**TRANSMISSION—E4OD—NEW DESIGN
INTERMEDIATE BAND APPLY SERVO ASSEMBLY**

**Article No.
95-23-14**

FORD: 1989-1996 BRONCO, ECONOLINE, F SUPER DUTY, F-150-350 SERIES

Figure 1 - Article 95-23-14

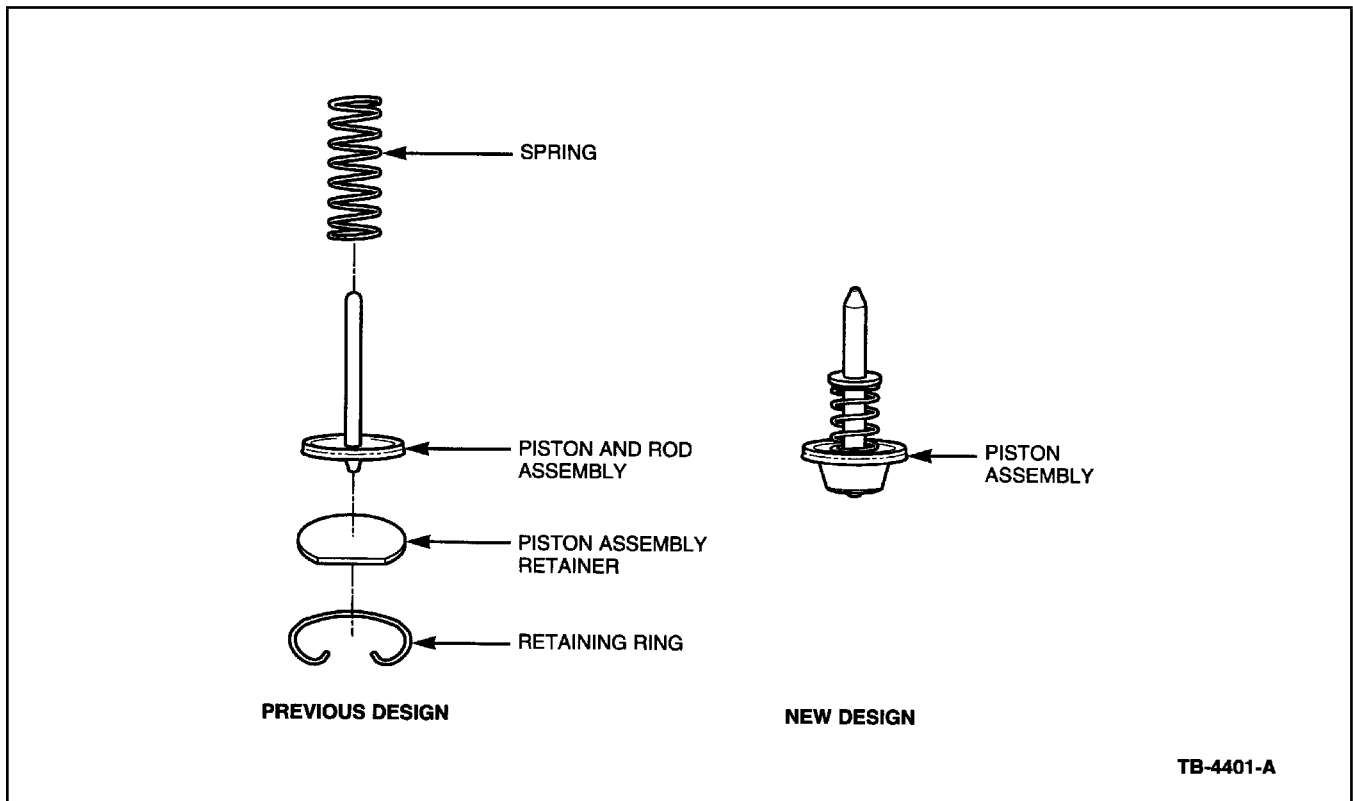
All E4OD transmissions built after August 7, 1995 have a new design Intermediate Band Apply Servo Assembly (F6TZ-7D021-A). This new design will service all past and present model E4OD transmissions.

When replacement of the Intermediate Band Apply Servo Assembly becomes necessary, either design (previous or new) can be used. Some transmissions built after August 7, 1995 do not have the retaining ring groove in the piston bore and only the new design piston and seal assembly can be used. Refer to Figure 1.

WHEN USING THE NEW DESIGN PISTON AND SEAL ASSEMBLY, DO NOT USE THE PISTON ASSEMBLY RETAINER OR RETAINING RING.
